PECOS DISTRICT DRILLING CONDITIONS OF APPROVAL

**ALL PREVIOUS COAs STILL APPLY. CEMENT DESIGN UPDATE AS PER
KPLA BEST PRACTICES (4-STRING INT1 X INT2 OPEN ANNULUS)**

OXY USA INCORPORATED		
BATCH SUNDRY ID: 2698966		
PRECIOUS 30-18 FEDERAL COM	3H	3001546350
PRECIOUS 30-18 FEDERAL COM	32H	3001546611
PRECIOUS 30-18 FEDERAL COM	43H	3001546614
PRECIOUS 30-18 FEDERAL COM	44H	3001546544
PRECIOUS 30-18 FEDERAL COM	171H	3001546581
PRECIOUS 30-18 FEDERAL COM	172H	3001546582
PRECIOUS 30-18 FEDERAL COM	175H	3001546457
PRECIOUS 30-18 FEDERAL COM	176H	3001546462

Oxy requests to update the Deep Intermediate Cement Job to align with the agreed upon R111-P updates presented from the JITC. (Below table based on Precious 30-18 Fed Com 175H)

Figure C] 4 – String – Un Cemented Annulus

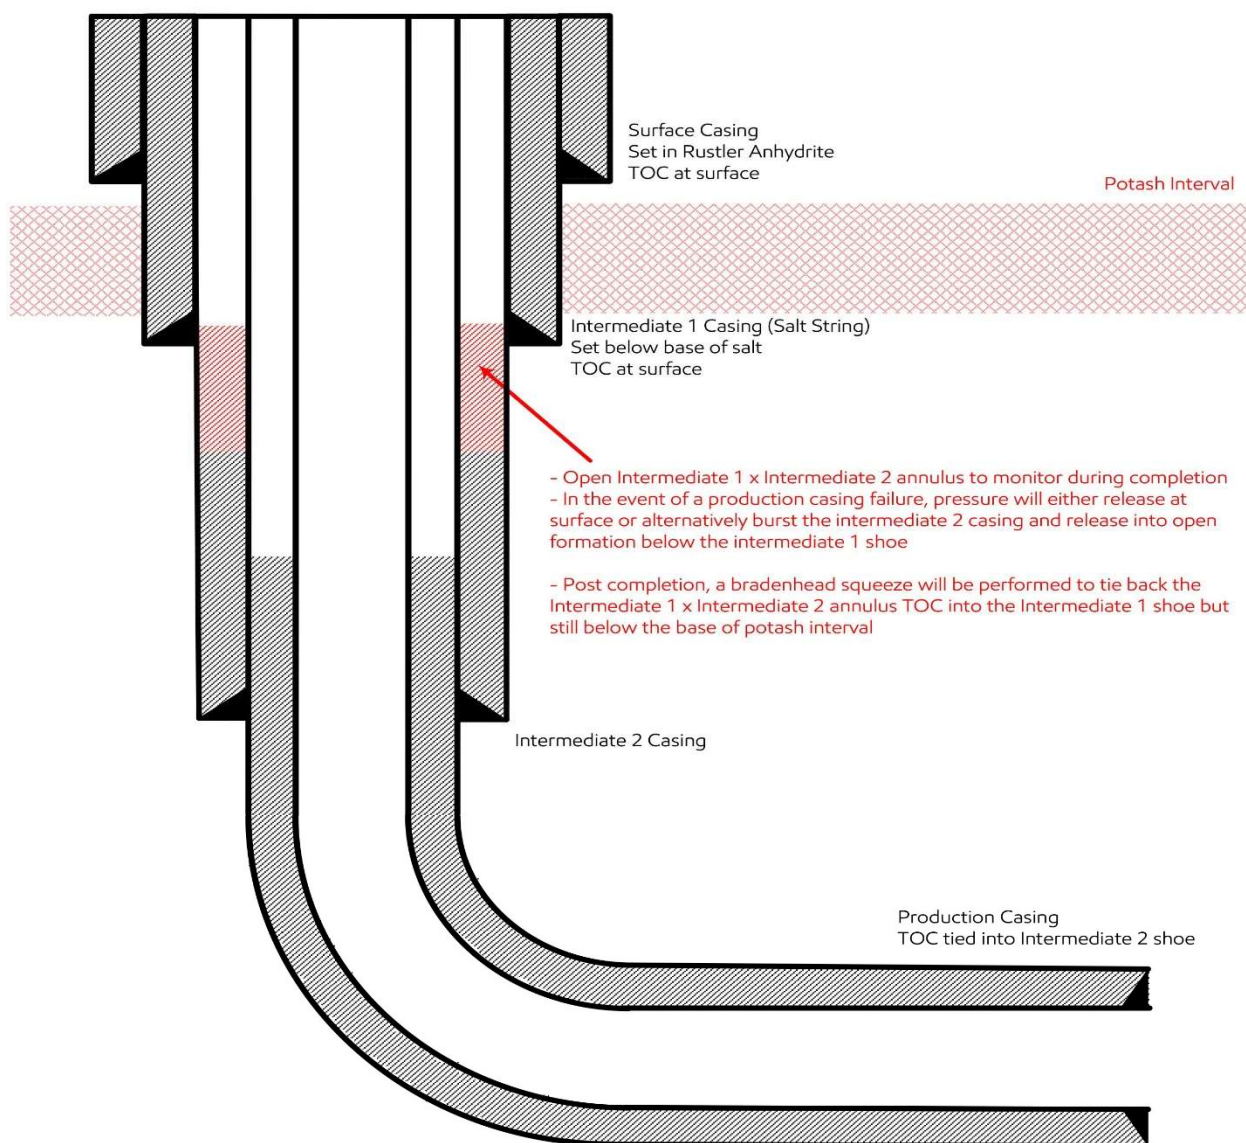
Operator has proposed to pump down 7-5/8" X 9-5/8" annulus POST-FRAC. Operator must top out cement after the bradenhead squeeze and verify cement to surface. Operator can also check TOC with Echo-meter. CBL must be run from TD of the 7-5/8" casing to surface if confidence is lacking on the quality of the bradenhead squeeze cement job. Submit results to BLM.

- Cement to surface. **AS PER MODIFIED DESIGN, THIS CAN BE ACCOMPLISHED POST-FRAC. Wait on cement (WOC) time for a primary cement job is to include the lead cement slurry due to cave/karst or potash.**
